CHAPTER 56 – YBD 2 and YBD 3 – Draft 6-10-2011

**Section 56.18
YBD 2, YBD 3**

Revised Draft 6-10-2011

Plate 34M: Street Improvements in YBD

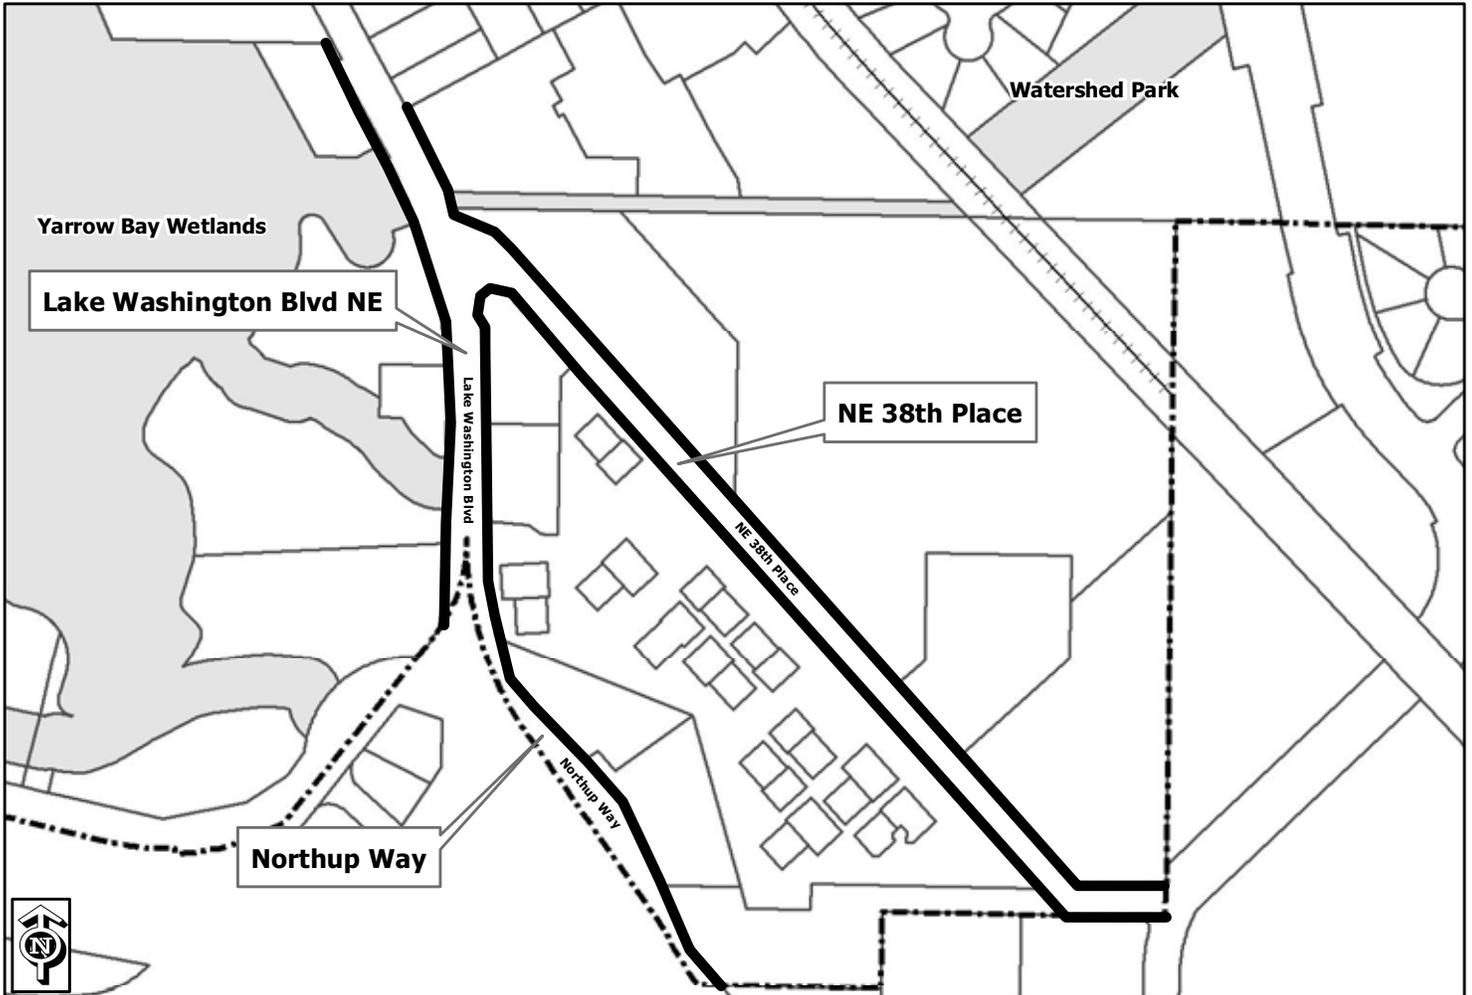
- Allow a 0' front yard setbacks along both NE 38th PI and Northup Way otherwise for all other streets 20' front yard setback (Lake Washington Blvd/Points Dr).
- Special Regulation 1 revision: Increase the limitation on size of individual retail uses from 15,000 to 65,000 sq. ft. consistent with the Rose Hill Business District
- For Lake Washington Blvd NE, NE 38th PI and Northup Wy provide a 10' wide sidewalk with street trees in tree grates and decorative pedestrian lighting (to be shown on Plate 34 M and referred to in KZC Chapter 110).

Required street improvements for NE 38th Pl, Lake Washington Blvd NE, and Northup Way in the Yarrow Bay Business District:
